Title: ERID-111328 SUBMITTAL OF THE RESPONSE TO THE NOTICE OF DISAPPROVAL FOR THE INVESTIGATION WORK PLAN FOR LOWER PAJARITO CANYON AGGREGATE AREA AND REVISION 1, INCLUDING 2 CD'S, EP2010-0521, EP2010-0522, LA-UR-10-7635

To:(Addressees - Organization) JAMES BEARZI, NMED

From:(Senders - Organization) MICHAEL J GRAHAM, LANL
 GEORGE J RAE, DOE

Figure 4.15-1 Site features of AOCs 18-006 and 18-013

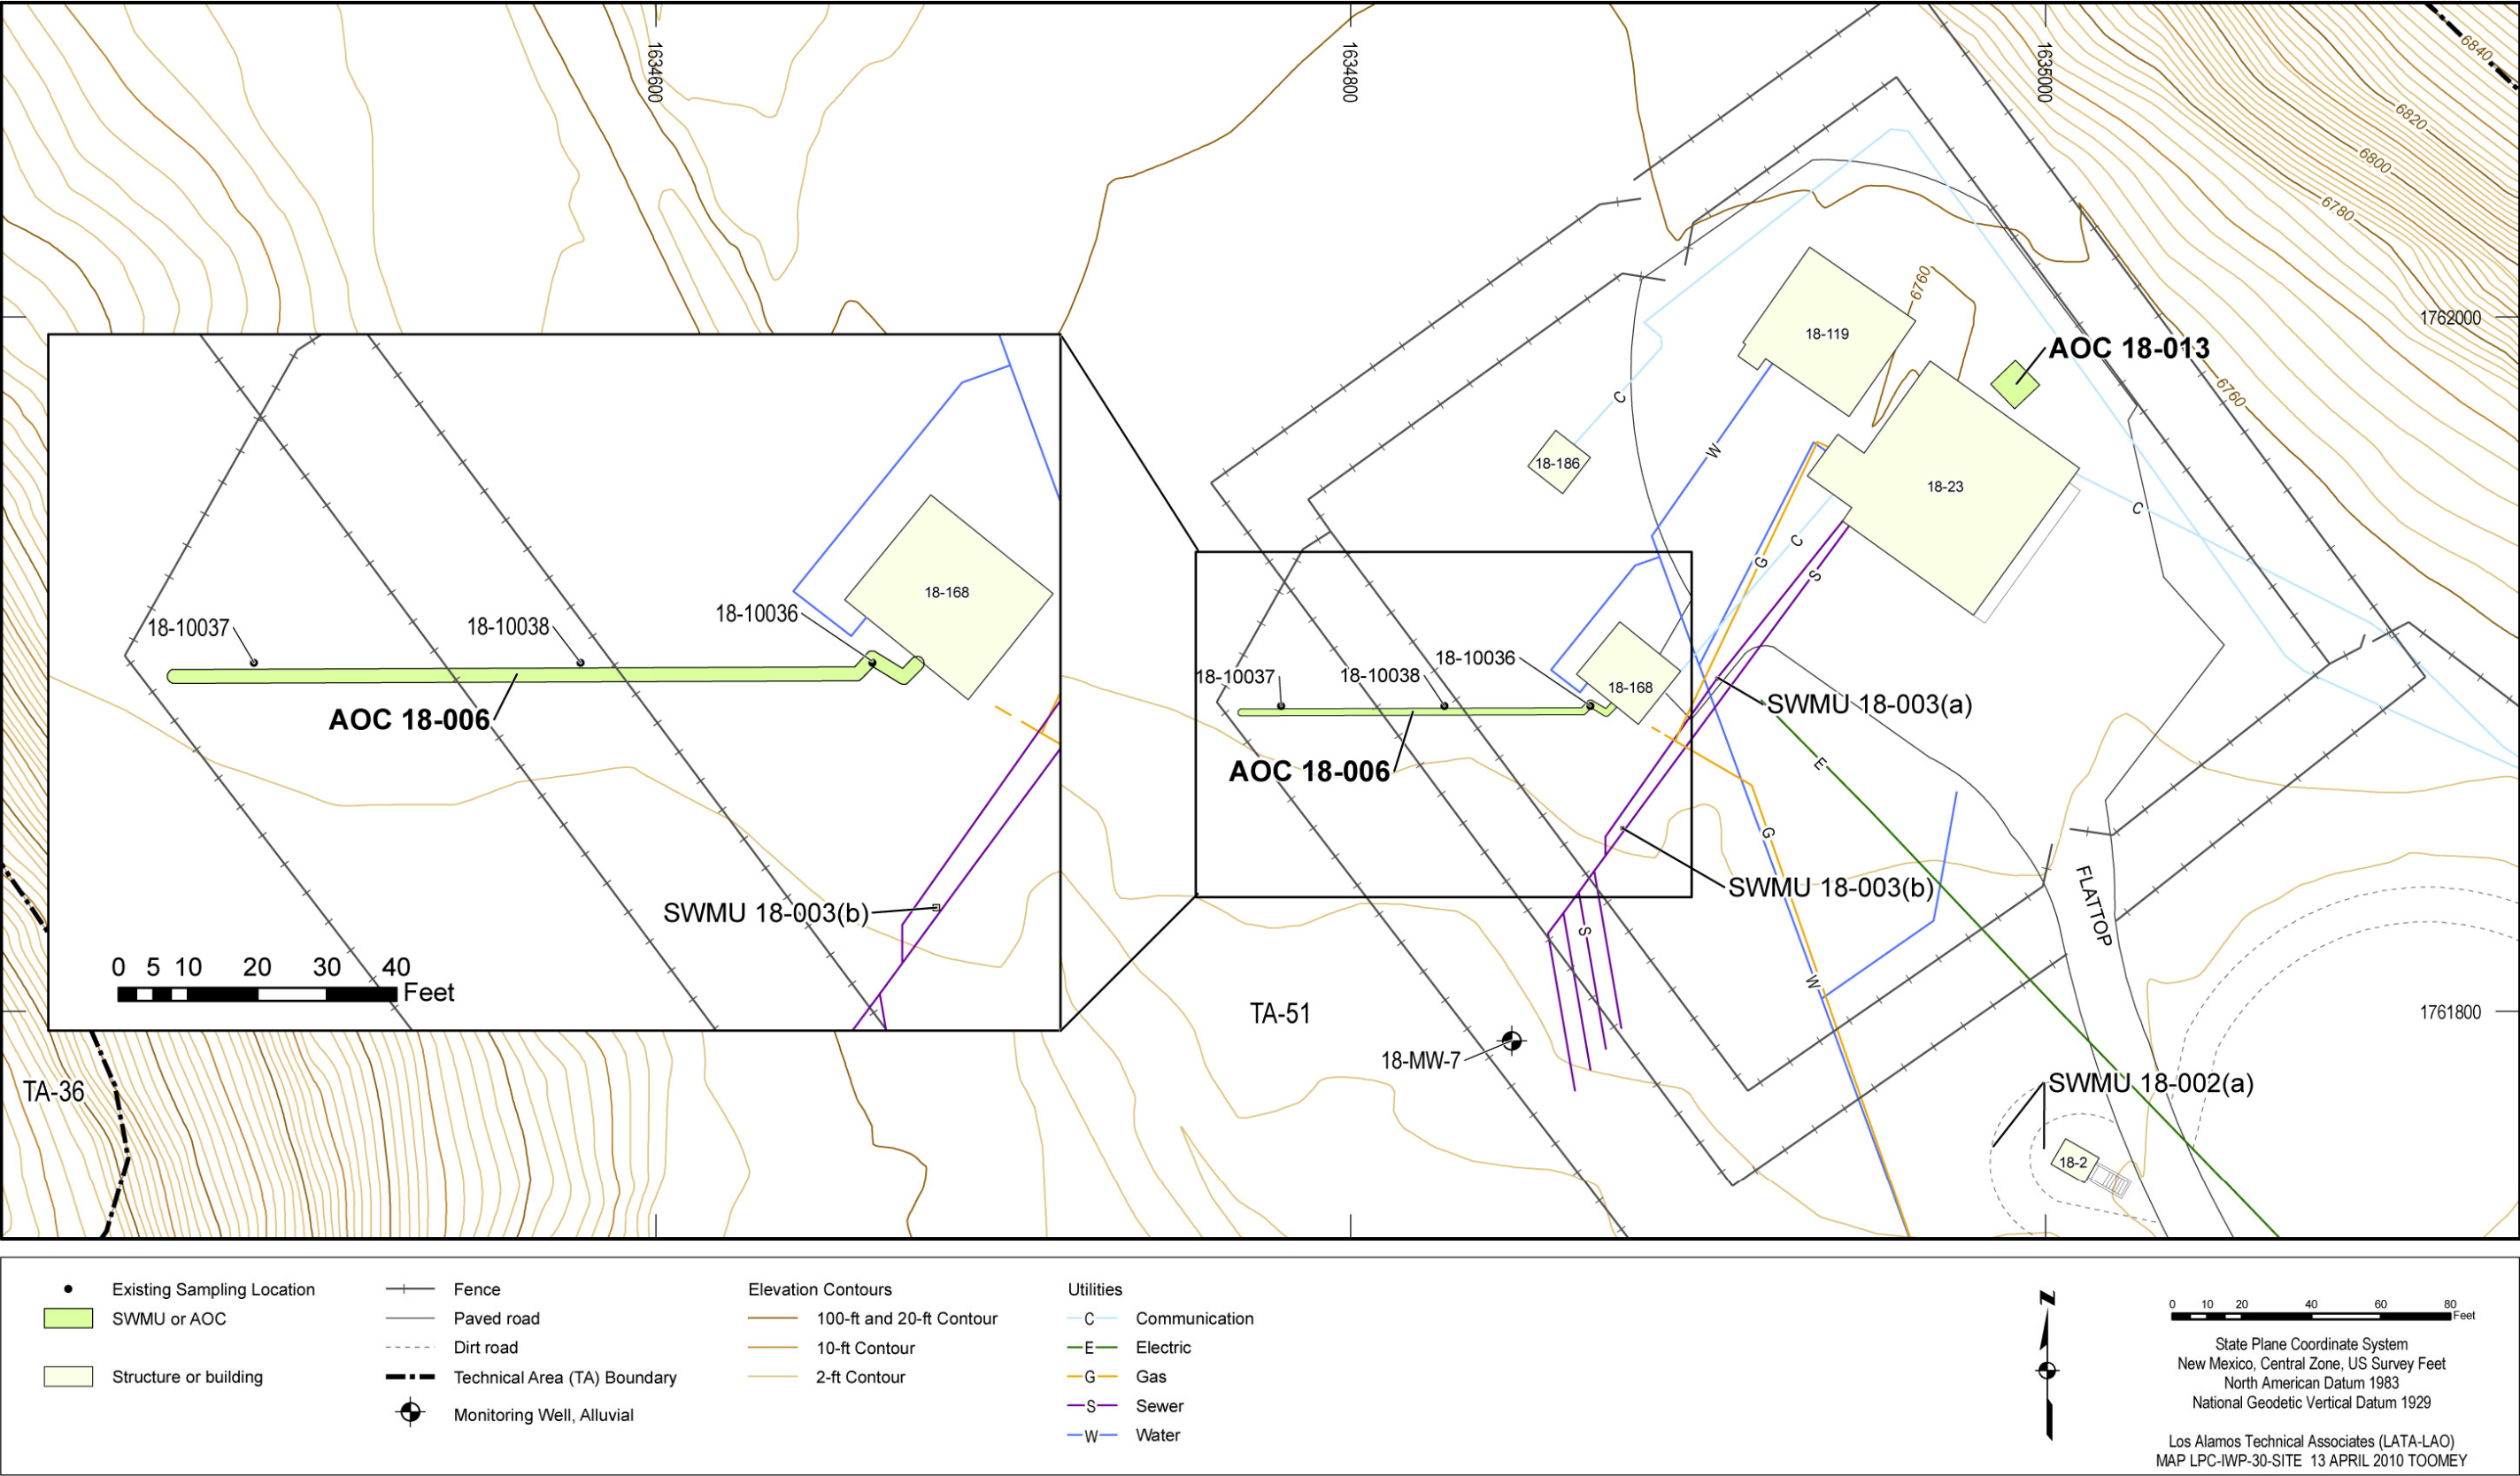
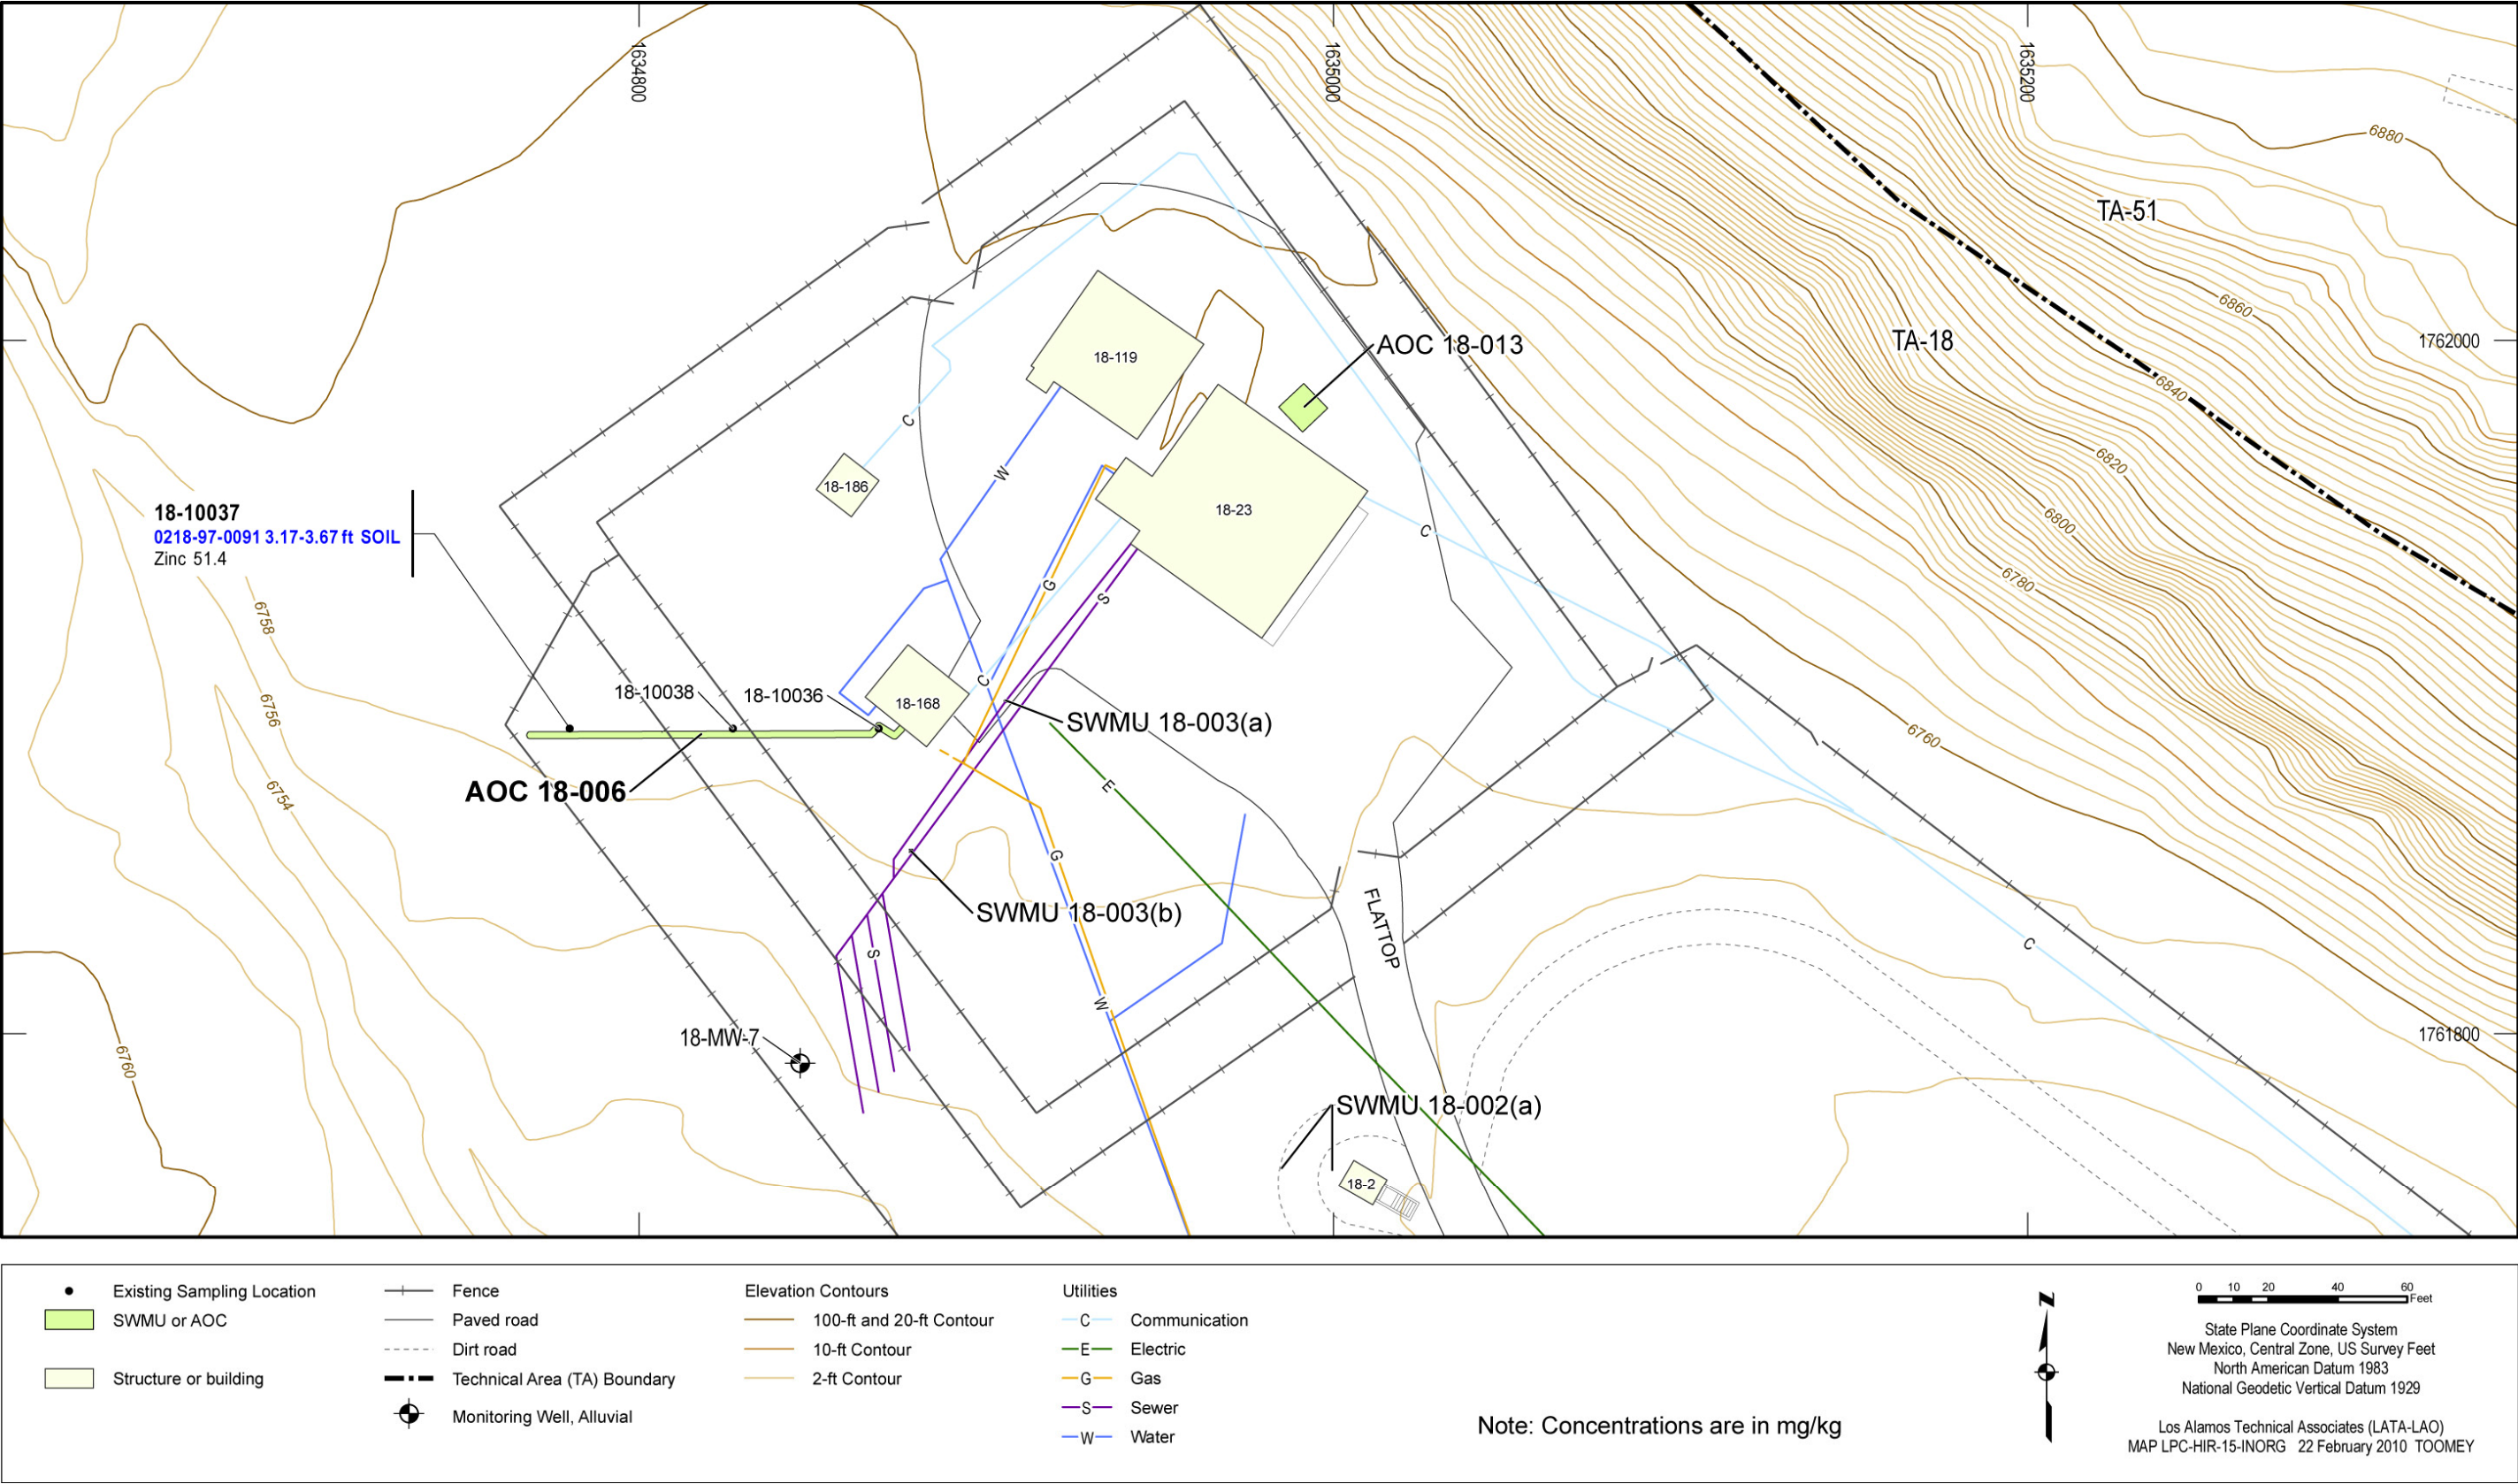
NMED Comment: One well (18-MW-7) is shown on Plan Plate 1. Verify this well is one of the four wells mentioned above. In addition, include all well locations on Plan figures associated with this

27. Well 18-MW-7 is one of the four wells mentioned in section 4.15.1. The well has been added to Figures 4.15-1 through 4.15-4. The other well locations are not included on the plan figures because they are located 1100 ft downgradient of AOC 18-006, beyond the depicted map area. The text in section 7.4 has been revised to state what measures will be taken in the event that groundwater is encountered while advancing the boreholes.
